Technical Memorandum

Review of Surface Water/Groundwater Relations Memoranda in the Cienega Creek Watershed

June 25, 2014

Prepared by: Tom Myers PhD, Hydrologic Consultant, Reno, NV

Figure 3. Probability plots with 95% confidence limits for normal and lognormal distributions.

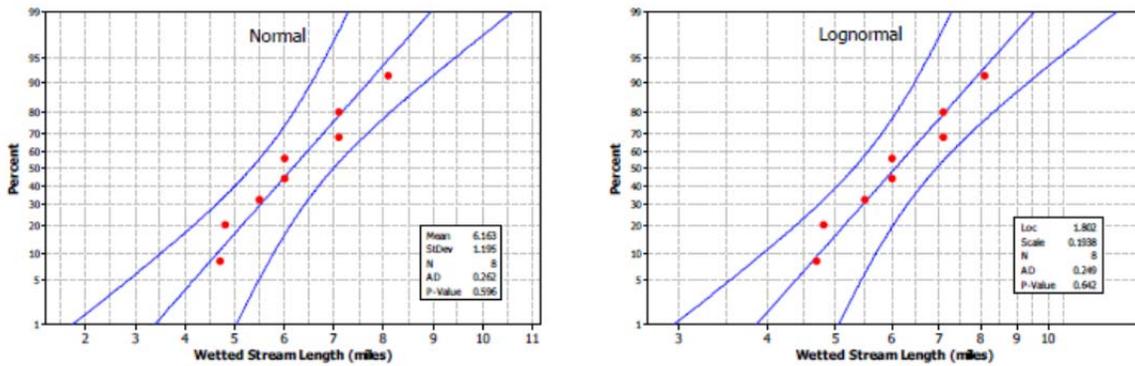
Rosemont fitted the wetted stream length data to various probability distributions so that they could use probability modeling to determine the probability of the stream being dry, or in probabilistic terms, the wetted stream length going to zero. There were just eight data points used, and the shortest wetted stream length is 4.7 miles, recorded in June 2013. Rosemont Table 12 presents results of a fit test showing that even the lowest test statistic, supposedly meaning the distribution that best fits the data, is not significant. Rosemont chose the log-normal and normal distributions because the test statistics were lowest. The following figures are from Rosemont (2014) and show the cumulative probability and the probability density for each of the chosen distributions. Their Figure 3 shows that the one percent cumulative probability is about 3.5 and 3.9 for the normal and lognormal distributions, respectively. That means that if the distributions accurately describe the wetted stream length, the return interval is 100 years for wetted stream length being less than 3.5 or 3.9 miles (probability of 0.01 corresponds to return interval if the wetted stream length can be considered an annual value, in this case the shortest length for the year). Rosemont Figure 4 shows that the probability of a wetted stream length being less than about 2.5 miles is much less than 1%.

It is apparent that Rosemont used probability distributions far beyond their population of data (the population being the measured wetted stream lengths). **No results using such a distribution can be considered credible because it is far beyond the realm of model calibration.**

Figure 7. Correlation between flow and wetted stream length as a function of averaging period.

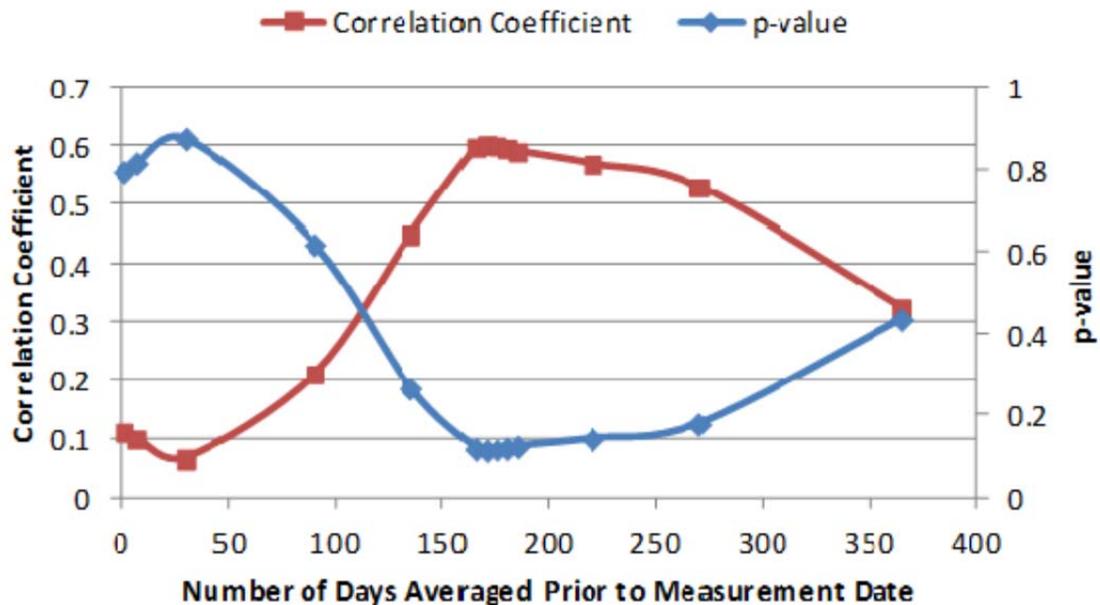
As part of their consideration of the Tetra-Tech model of decreased streamflow, Rosemont correlated flow of various metrics with the wetted stream length. As the following figure, snipped from Rosemont (2014) shows, the average of the gaged flow for the previous 170 days correlated the best, meaning that wetted stream length depends most on the previous six months climatology rather than short-term flows. The correlation was non-parametric and the linear regression completed to obtain 4.35 miles of stream length lost for a 1 cfs change in flow is inappropriate because linear regression assumes normality. **The R^2 is low and non-significant, therefore it is inappropriate and incorrect to claim that a 0.08 cfs predicted reduction in flow can translate into a 0.334 mile reduction in wetted stream length.** Additionally their Table 11 shows that the range in wetted stream length is from 4.7 to 8.1

miles which is a significant scatter in their regression (there is no scatter plot of the wetted stream length to any of the flow metrics). Finally, it is inappropriate because Tetra Tech’s simulated flow rate would be base flow, not the 170-day flow preceding the wetted stream length measure as used in the equation.

Simply, Rosemont used inappropriate flows and inappropriate probability distributions to estimate the probability of a dry stream. Their finding that even adding the drawdown causes essentially no chance of a dry stream is meaningless because it **is based on stretching empirical data far beyond their range**. The discussion of climate change effects simply adds one more bit of speculation to the calculation because they have to translate an annual streamflow reduction into an annual hydrograph when the effect in reality will vary through the year.
